September 16, 2022

**RE: Lot 24 Block 6 Unit 18 SAD 228
6515 Pato Rd. NW
Volcano Cliffs Subdivision
Grading and Drainage Plan
Engineers Stamp Date 5/12/2020 (D10D003M24)
Pad Certification Date: 6/30/2020
CO Certification Date: 9/15/2022**

GRADING AND DRAINAGE PLAN

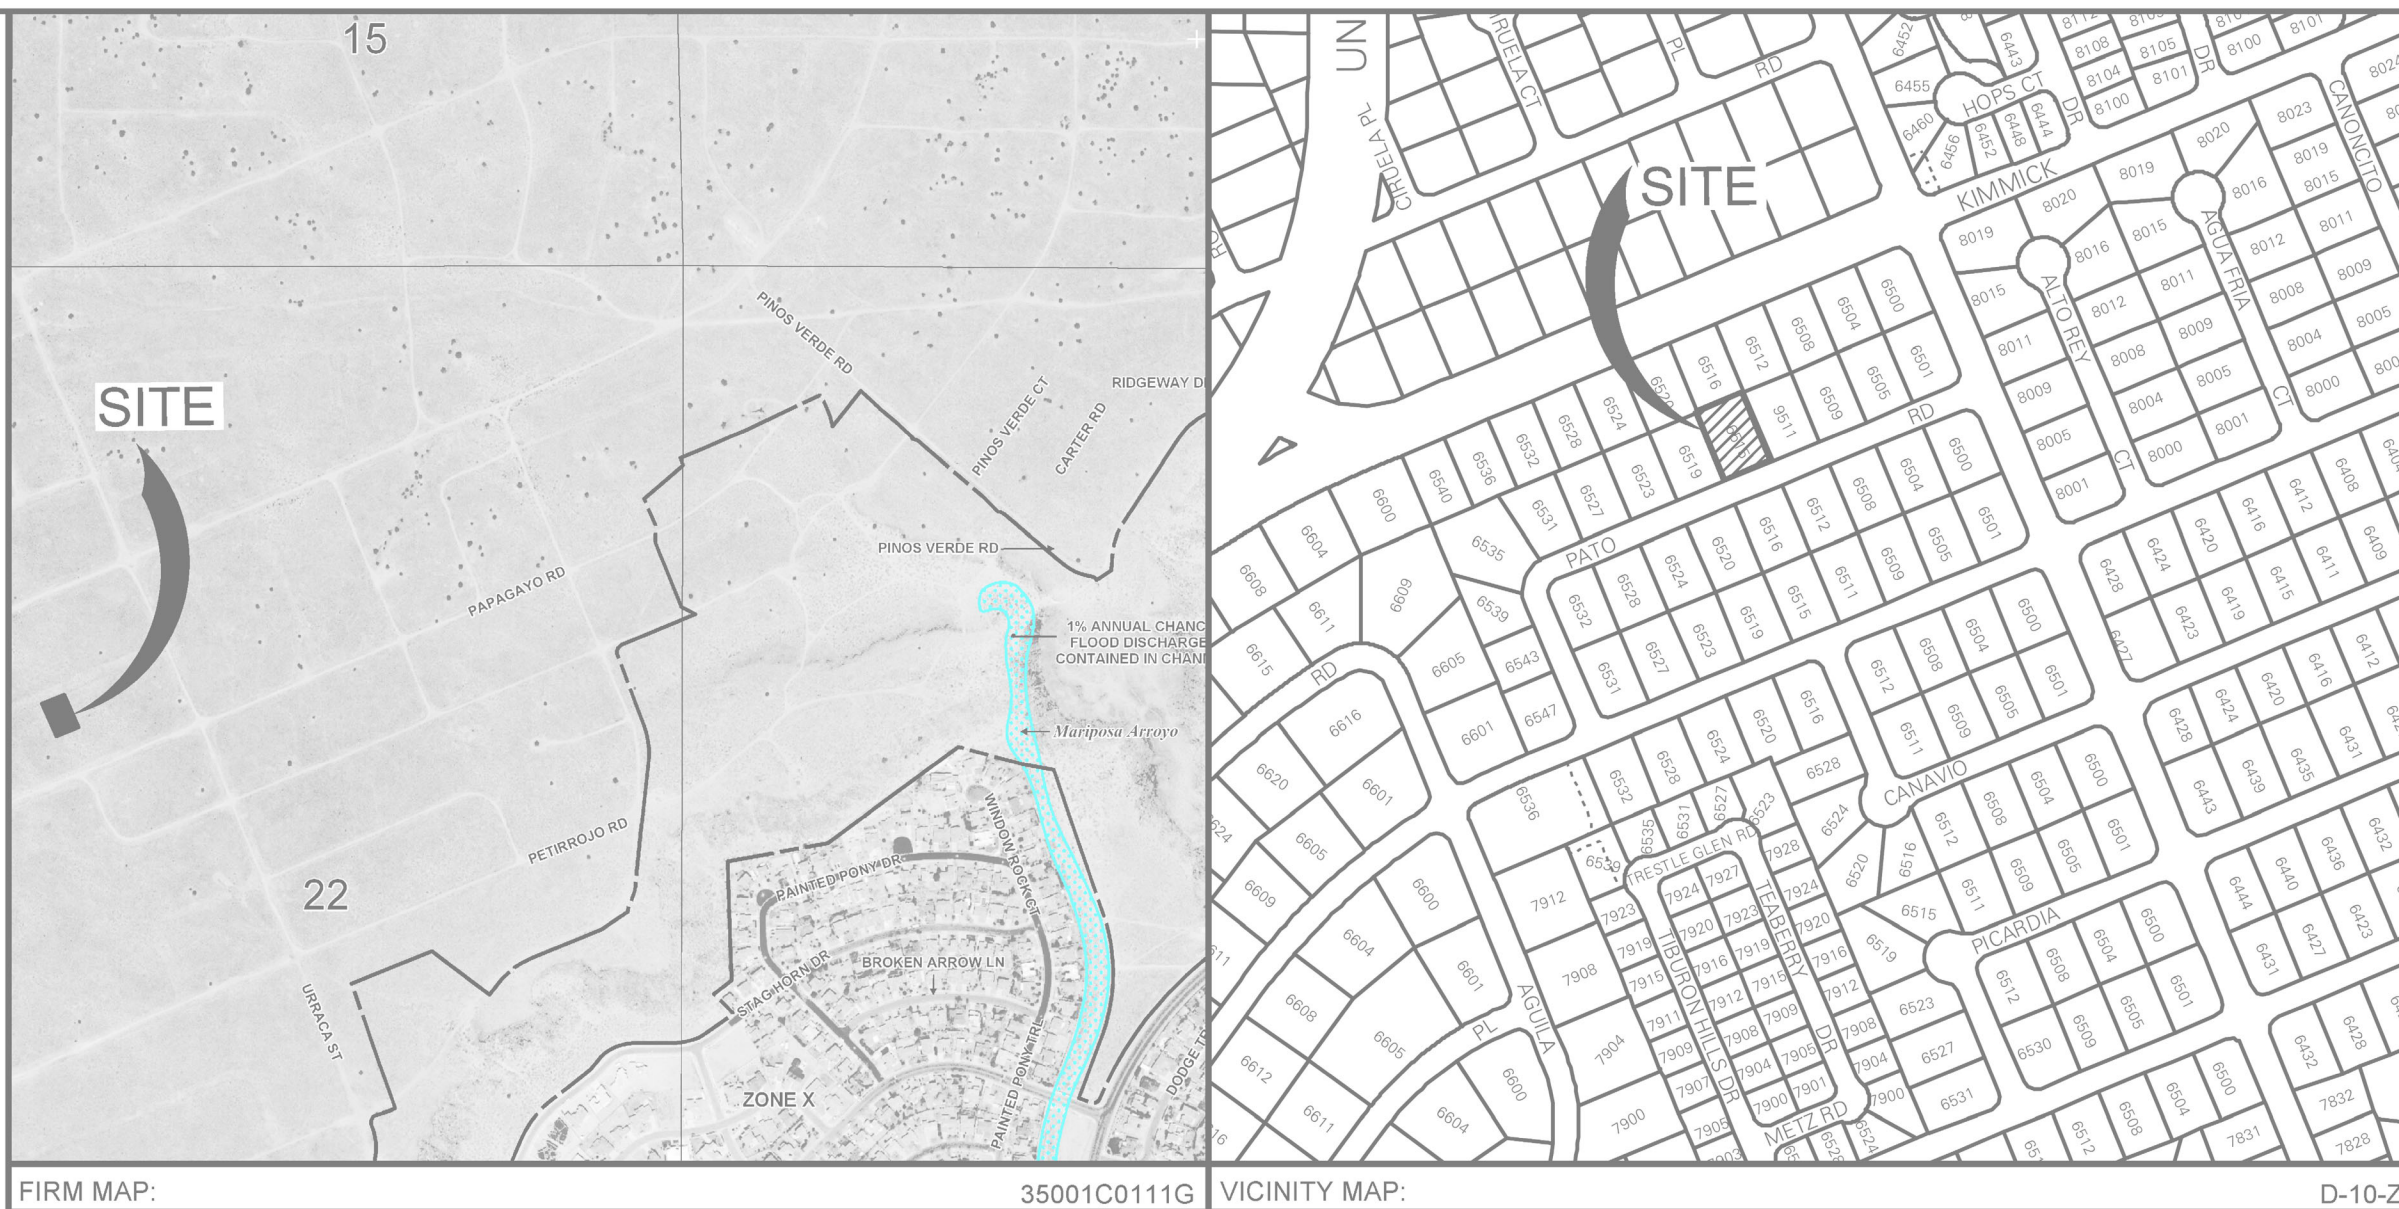
Based upon the information provided in your submittal received 9/15/2022, this plan cannot be approved for Certificate of Occupancy until the following comment is addressed.

- The public sidewalk must be fixed. There is a missing 4' section and the other two sections are not in the right position.
